ASCE 41-17 Tier 1 and Tier 2 Seismic Evaluation Report Rossmoor Buildings:

600 Terra California Drive, Walnut Creek, CA

December 12, 2022

IDA Job No. 22054

MITIGATION PLAN

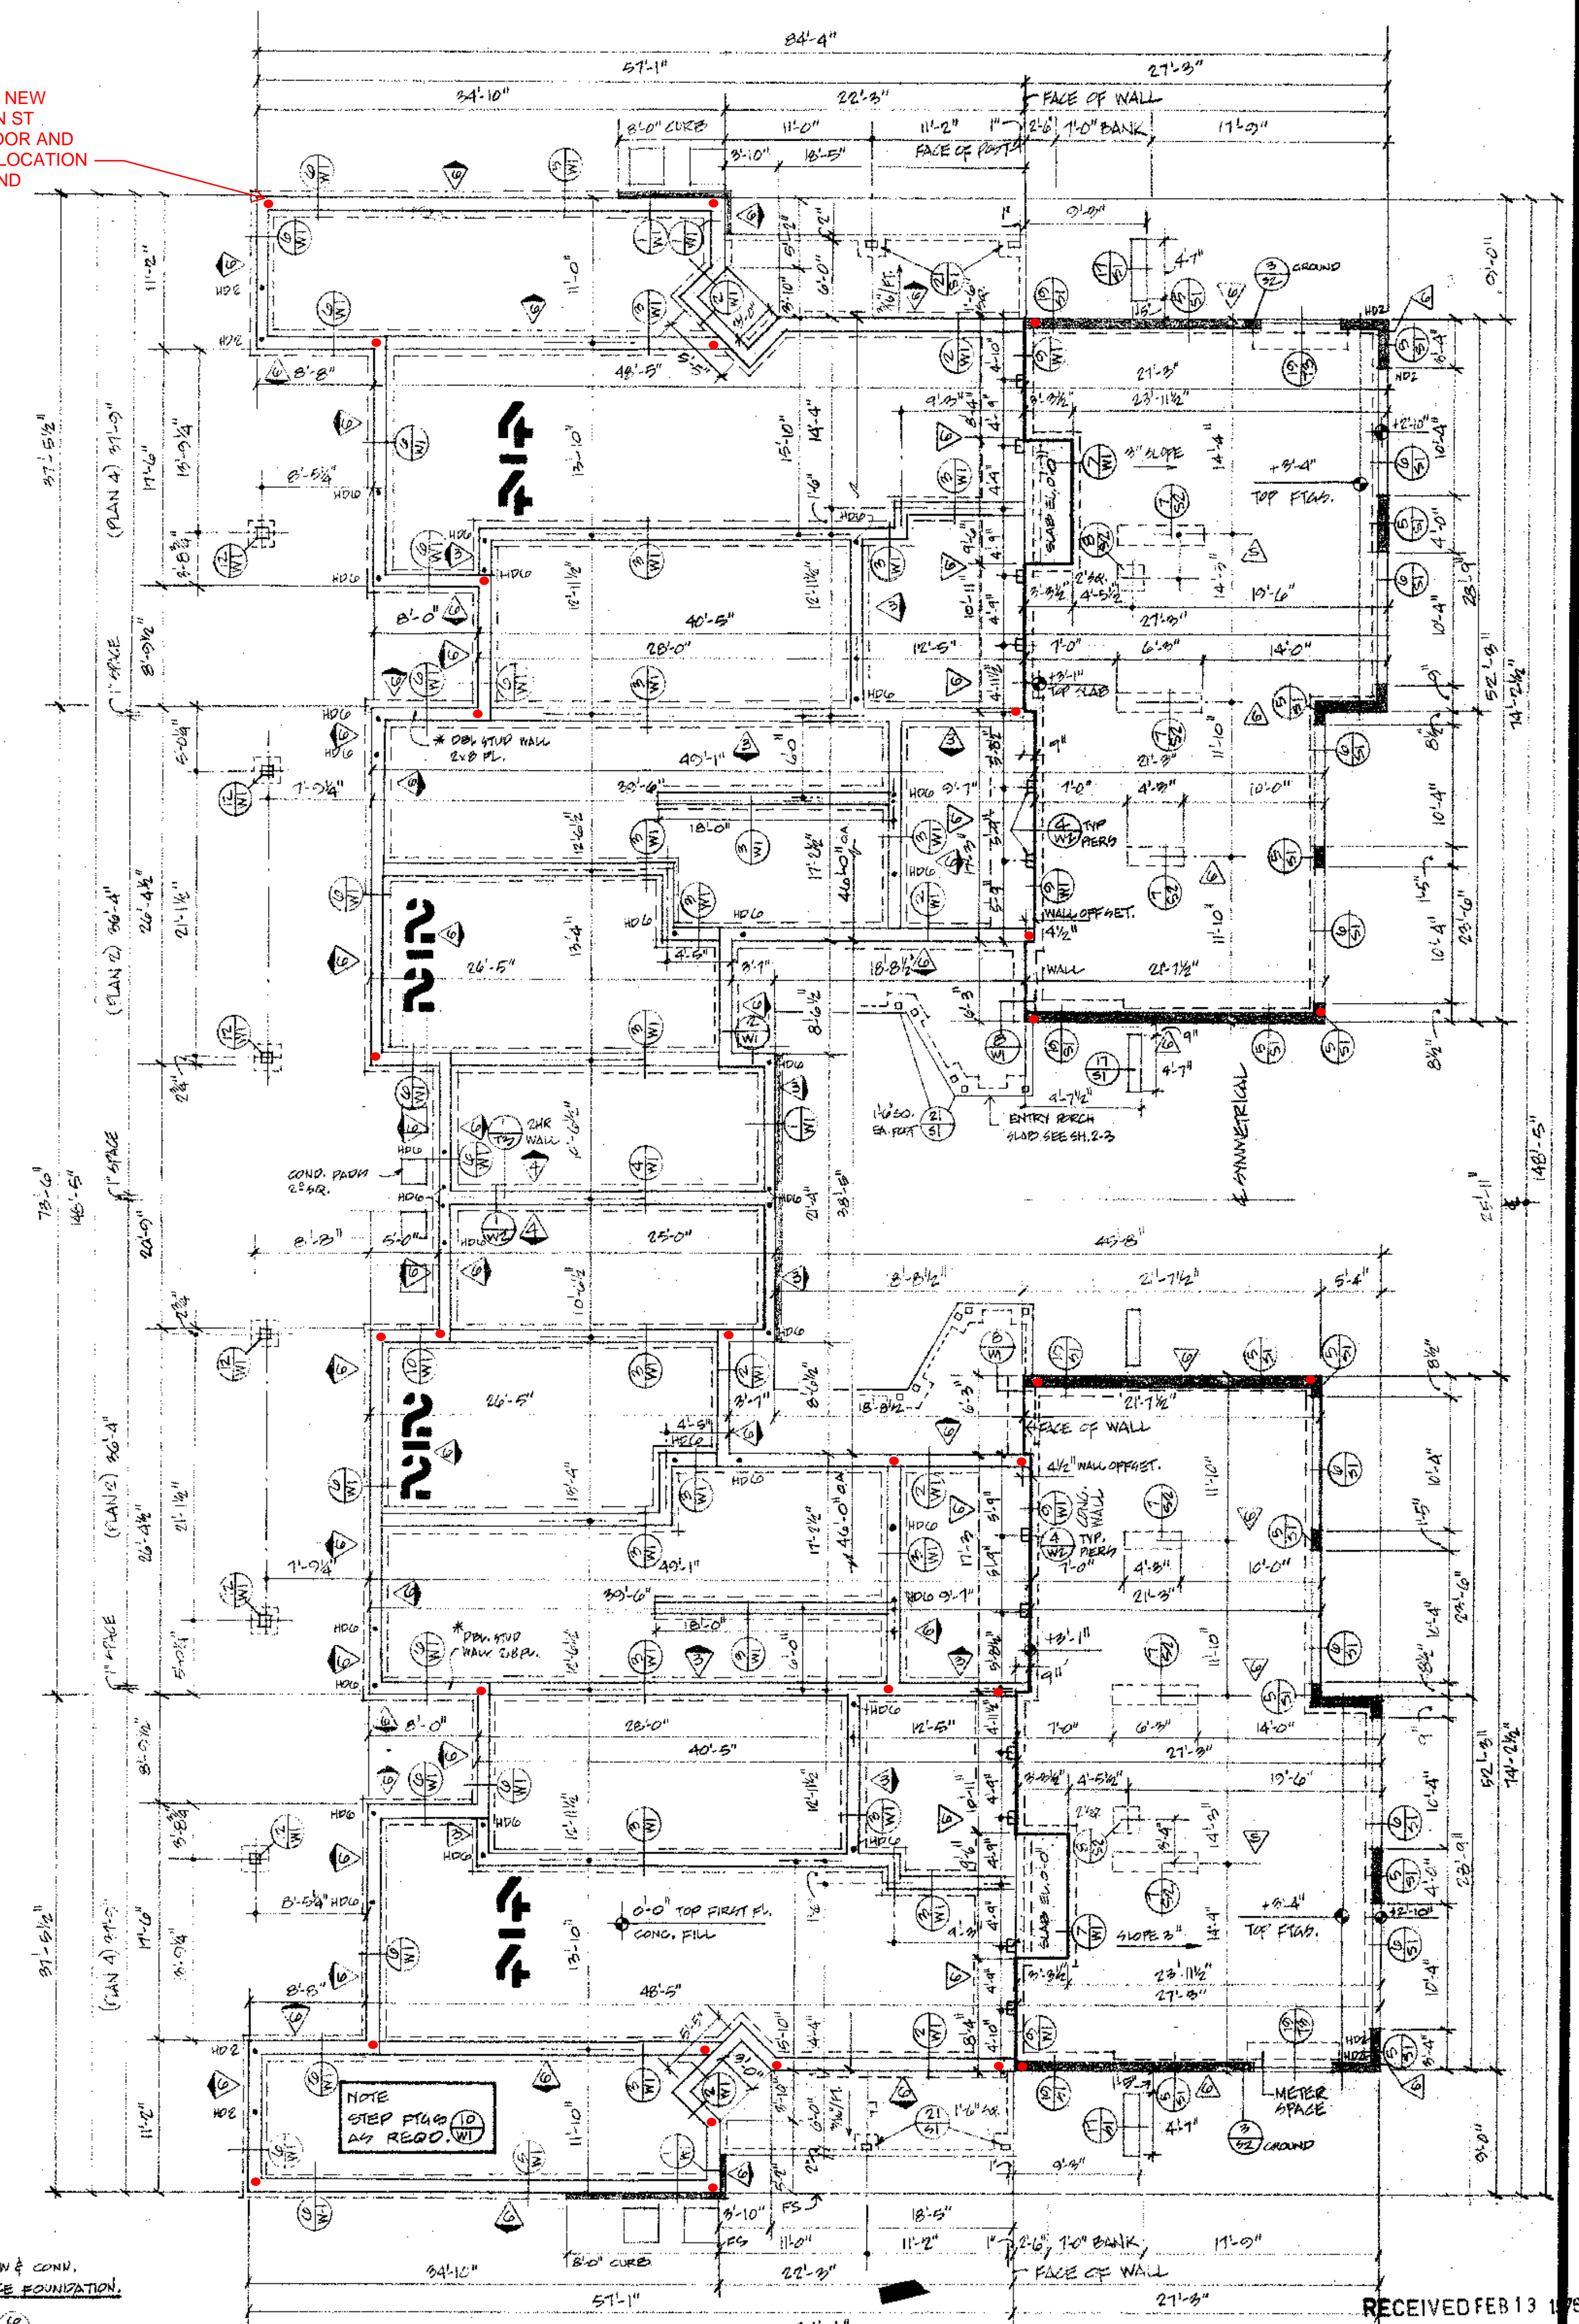
The shear walls do not have interconnection ties to transfer overturning forces through the floor. Shear walls in East-West direction do not have holdowns called out on the plans. Shear walls without holddown anchors may be subjected to significant overturning, and damage can be caused by uplift and racking of the shear walls. Hold down anchorage can help resist overturning forces and can greatly strengthen shear walls vs. walls without anchorage.

While the building has holdowns in the transverse loading direction, holdowns appear to be missing in the longitudinal loading direction. In some cases, the original designer of the building may have assumed there was sufficient dead load to resist overturning forces. Lower seismic forces at the time of design may have allowed for this design. However, wood shear walls without holdowns or ties between floors have reduced ductility and may be subject to overturning at excessive deflections. Seismic demands have increased, and detailing demands have become more stringent since the original construction. Therefore we conclude the building has an incomplete lateral force resisting system, which does not meet the requirements of ASCE 41-17 for the BPOE performance. Retrofitting these conditions are required to meet the Structural Performance Level of the BPOE.

New straps can be added at shear walls to transfer overturning forces between floor to floor. Shear walls without hold downs should be retrofitted with hold down hardware and compression posts. New hold down hardware could be retrofitted at shear wall ends and anchor bolts would need to be epoxied into the existing foundations. Compression posts could be installed along with the hold down hardware as required. Foundation strengthening may be required if existing foundations are shallow or weak in local areas.

DENOTES NEW
HOLDOWN ST.
FIRST FLOOR AND
AT SAME LOCATION
ON SECOND
FLOOR.
TYP.
